McDONALD'S RESTAURANT
2017 MAJOR REMODEL PROGRAM
State Site Code: 022-0316 Nat'l Number: 18751
7997 SOUTHTOWN CIR. BLOOMINGTON, MN

A2.1

1 FLOOR PLAN

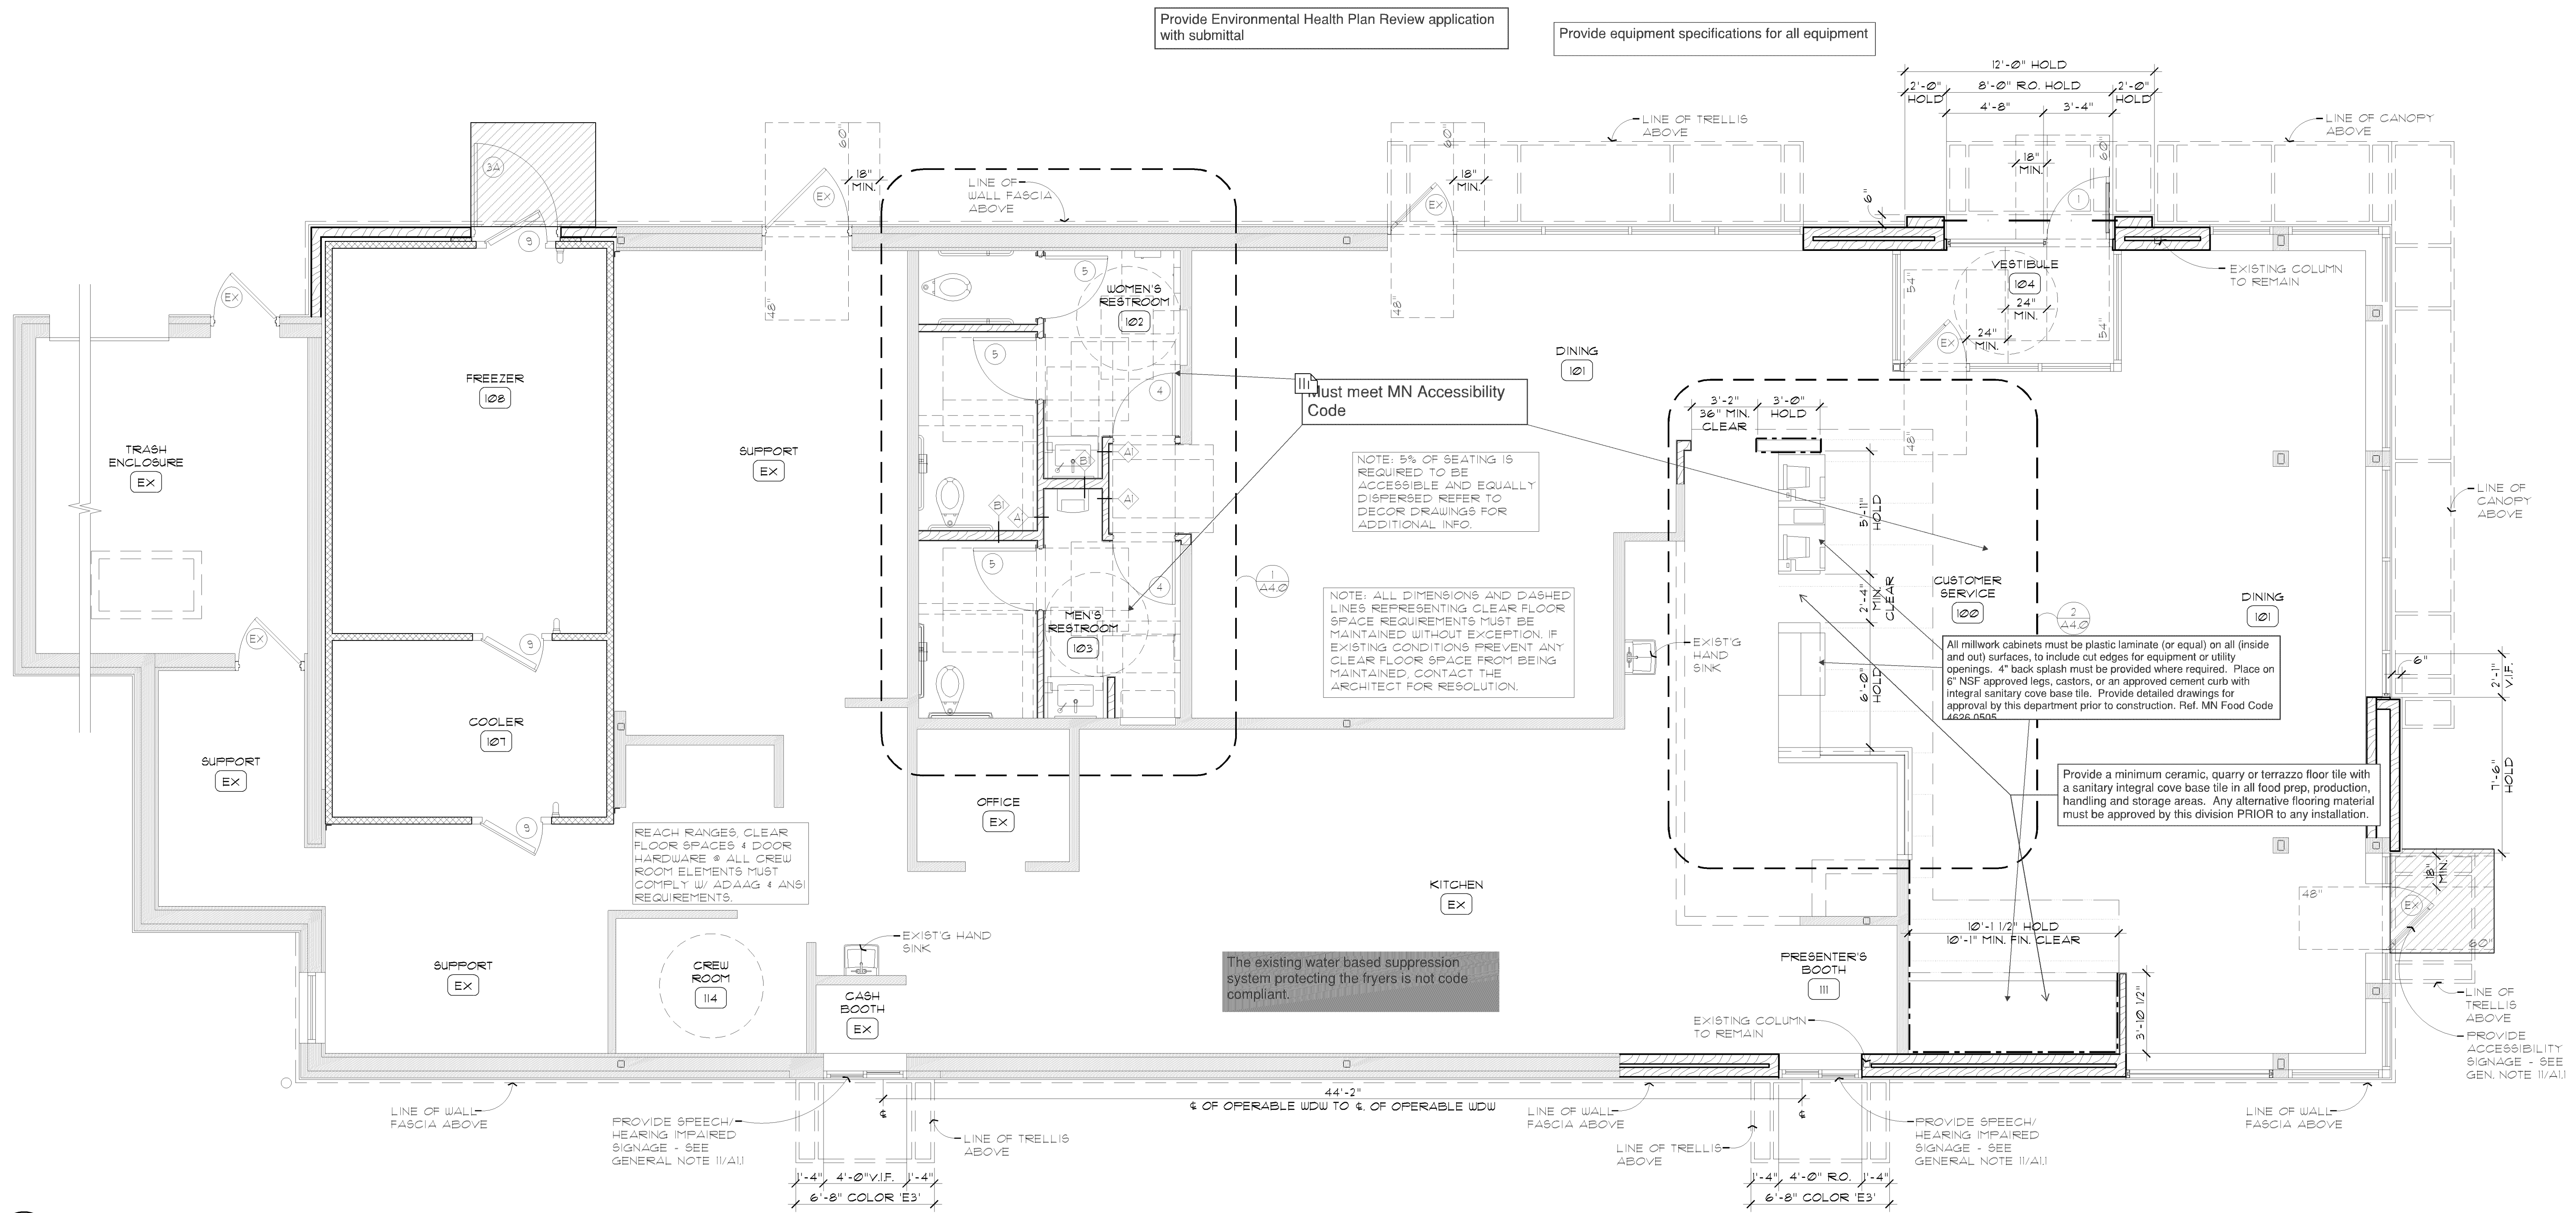
Provide Environmental Health Plan Review application with submittal

Provide equipment specifications for all equipment

Must meet MN Accessibility Code

The existing water based suppression system protecting the fryers is not code compliant.

Must meet current MN State Building Code

20% of budget must be applied to accessibility updates(remodels)?????
